PALISADES NUCLEAR PLANT  
DOCKET NO. 50-255  
LICENSE DPR-20  
CORE OPERATING LIMITS REPORT – REVISION 11

**PALISADES CORE OPERATING LIMITS REPORT  
Revision 11**

**Summary of Changes**

**Figure 2.2-1 Regulating Rod Group Position Limits**

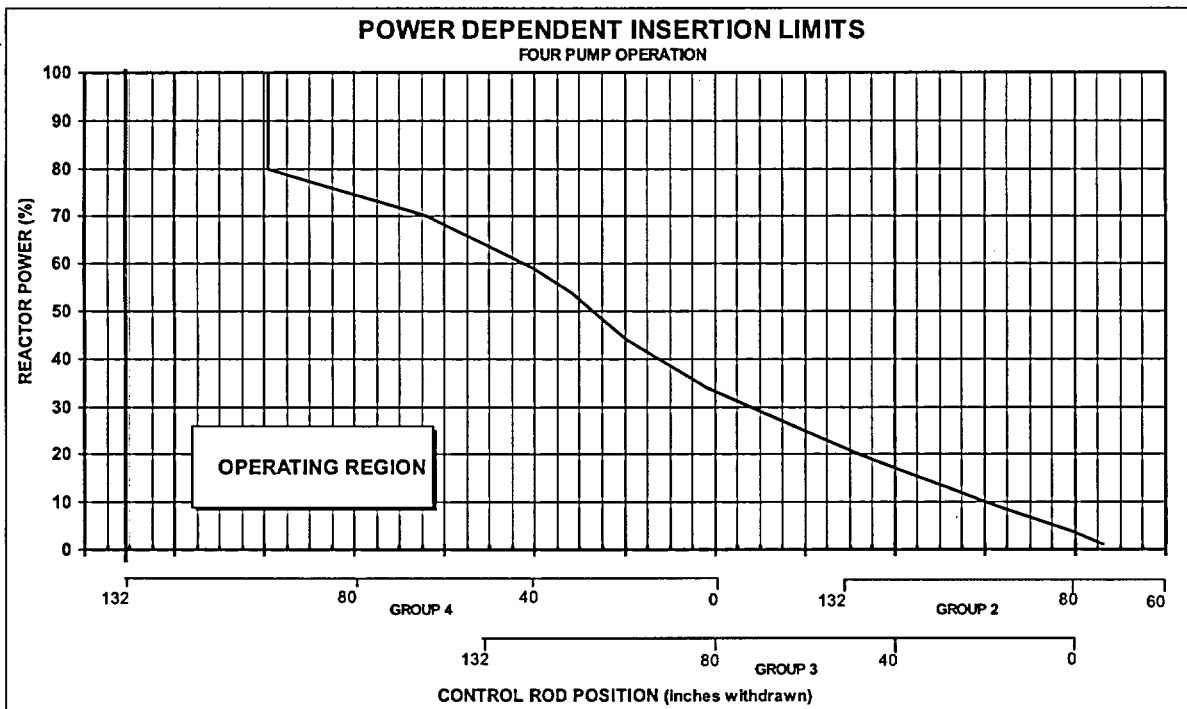
A note is added to figure 2.2-1 to indicate that a regulating rod is considered fully withdrawn at  $\geq 128$  inches.

**NOTE:** A regulating rod is considered fully withdrawn at  $\geq 128$  inches.
